Leslie Moody and Mitchell Ackerman, Applicants, JenkinsGavin, Agents, request Master Plan Zoning, Preliminary and Final Development Plan approval to allow a Bed and Breakfast within an existing residence on 9.94 acres. The property is located on the west side of Highway 14 off Bonanza Creek Road (County Road 45), within Section 26, Township 15 North, Range 8 East (Commission District 5).

RE: 31 Bonanza Creek Road
Application for Master Plan and Preliminary/Final Development Plan

RE: 31 Bonanza Creek Road
Application for Master Plan and Preliminary/Final Development Plan
Response to Comments

REVIEW SUMMARY: CDRC CASE # MP/PD/DP 31 Bonanza Creek Application dated January 14, 2014 for Master Plan, Preliminary and Final Development Plan approval to allow a Bed and Breakfast Inn and prepared by Jenkins Gavin Design & Development Inc. has been reviewed for compliance with the Santa Fe County Sustainable Growth Management Plan (SGMP).

LANDSCAPE & WATER HARVESTING PLAN

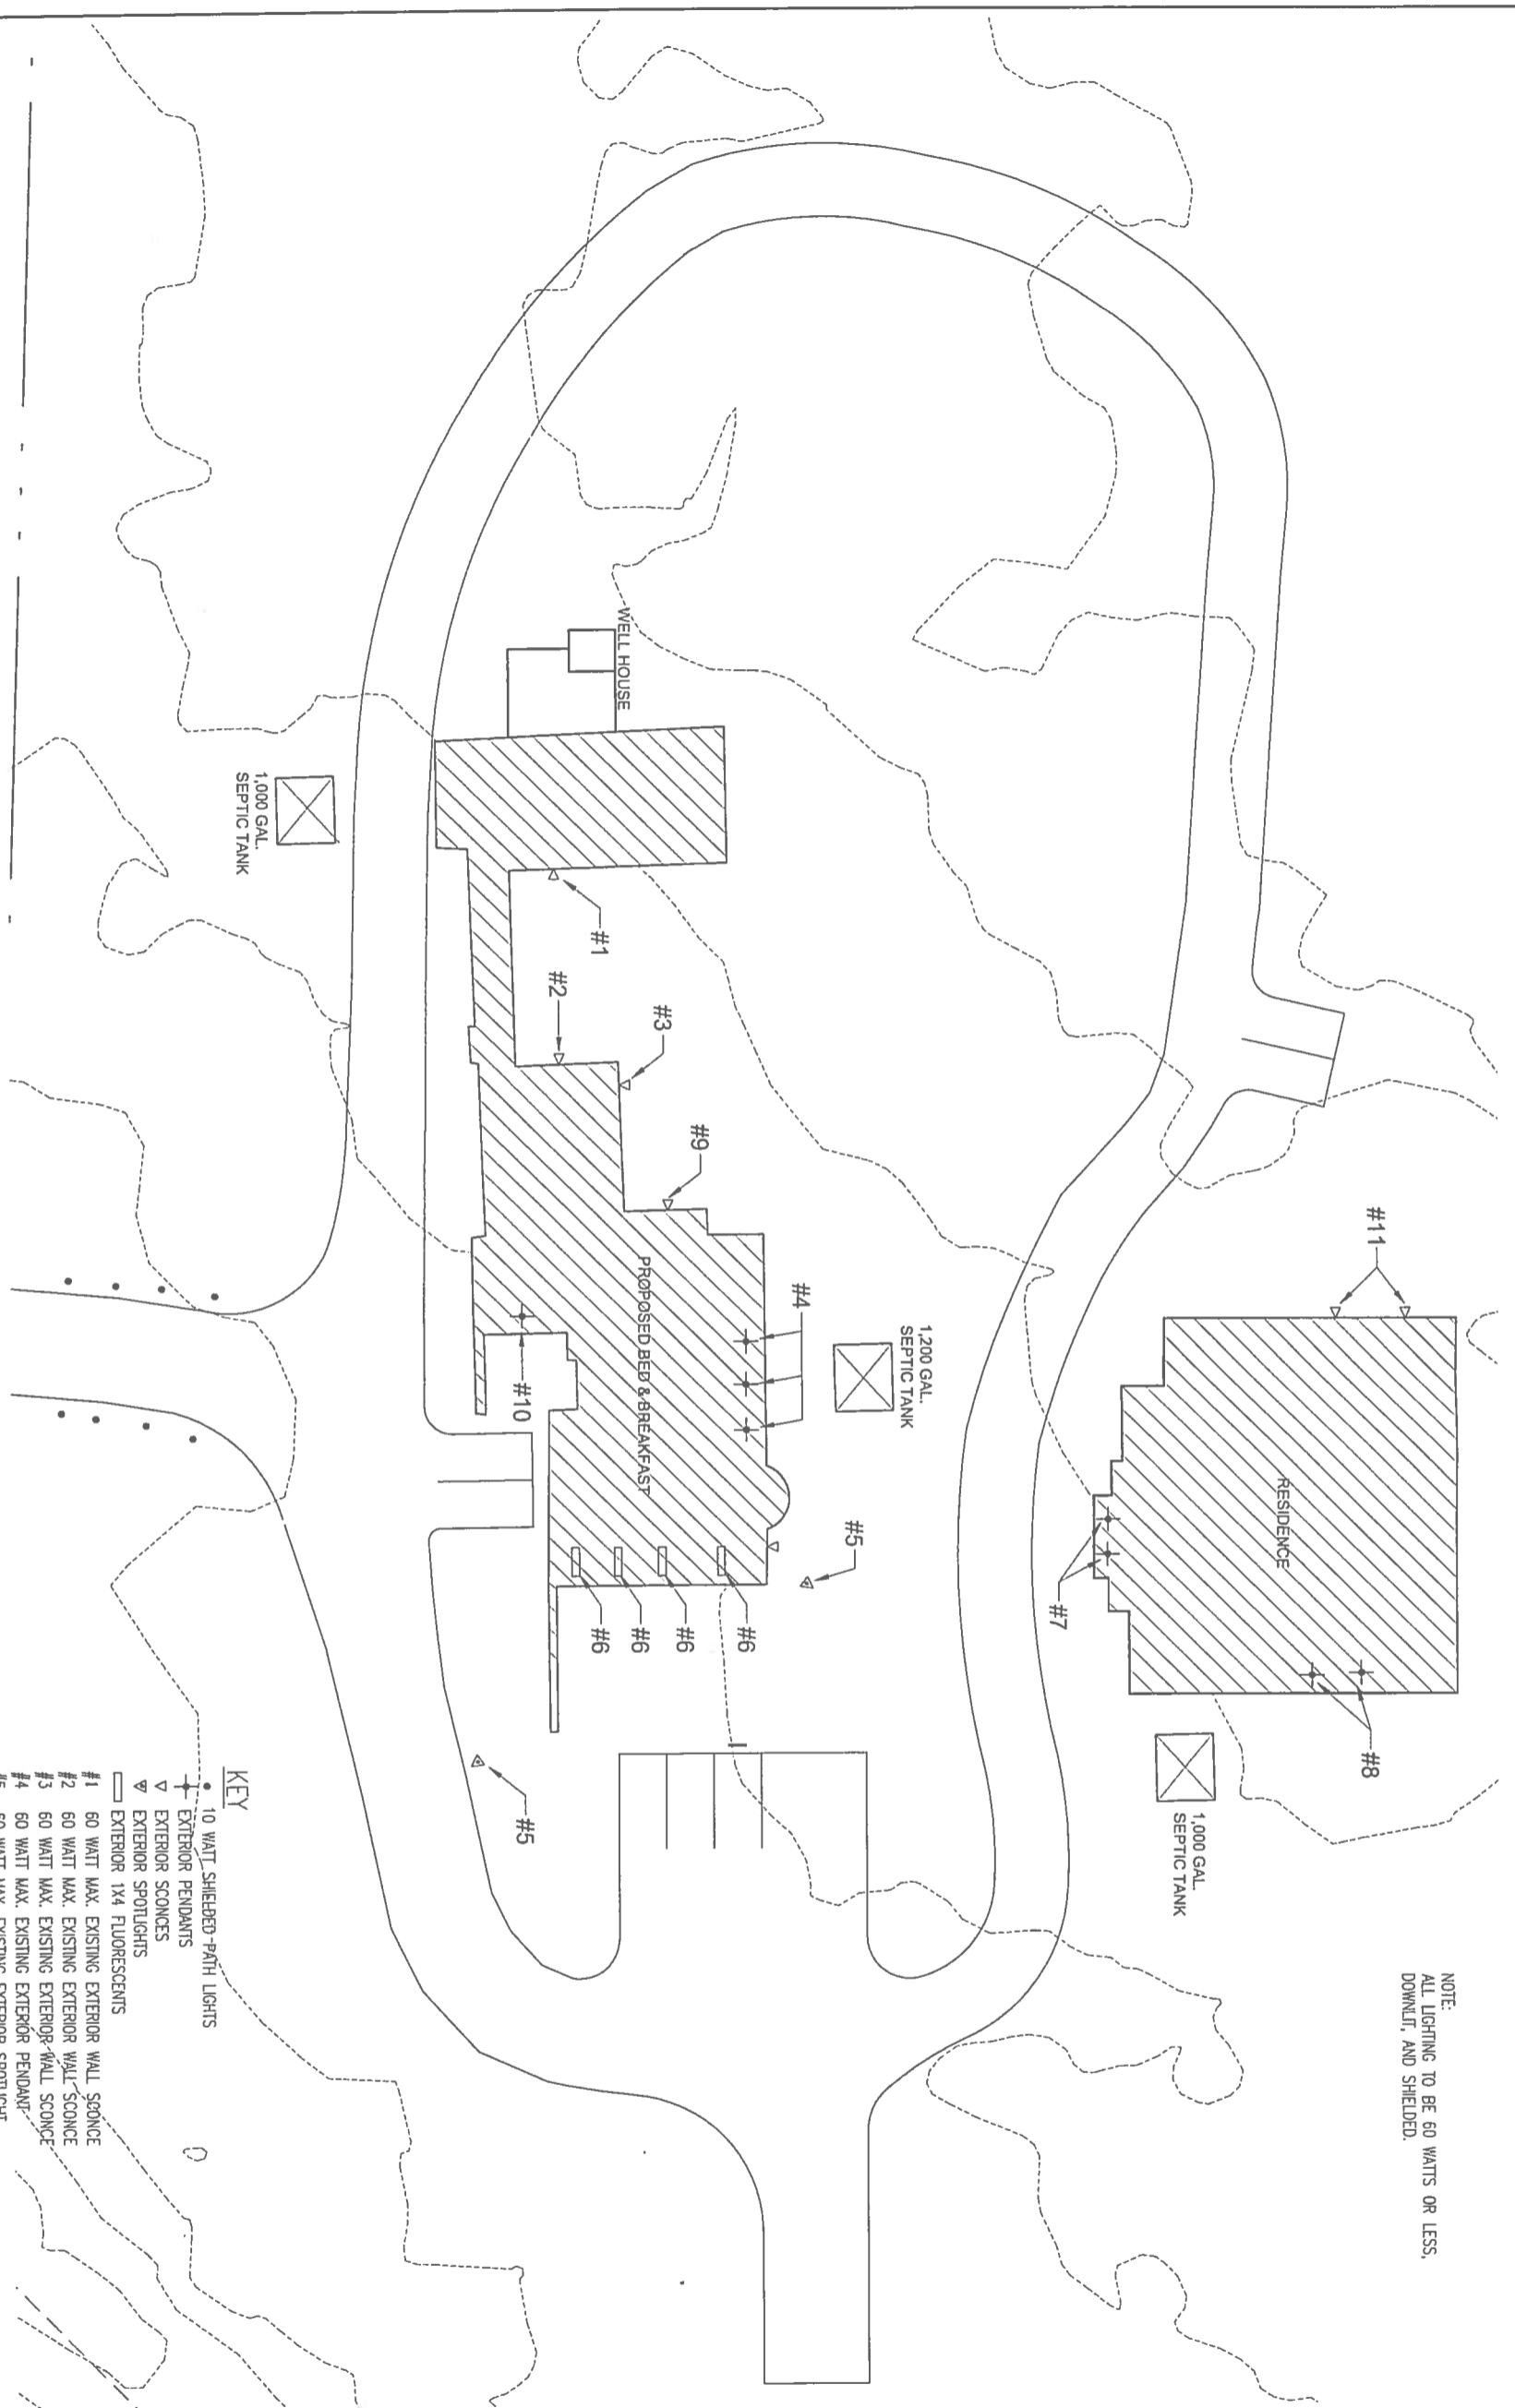
The revised Landscape and Water Harvesting Plan is attached indicating the change to a 5,300 gallon cistern that will accommodate one month's irrigation demand in accordance with the Landscape Water Budget. Also, the cistern and irrigation specification are included as requested.
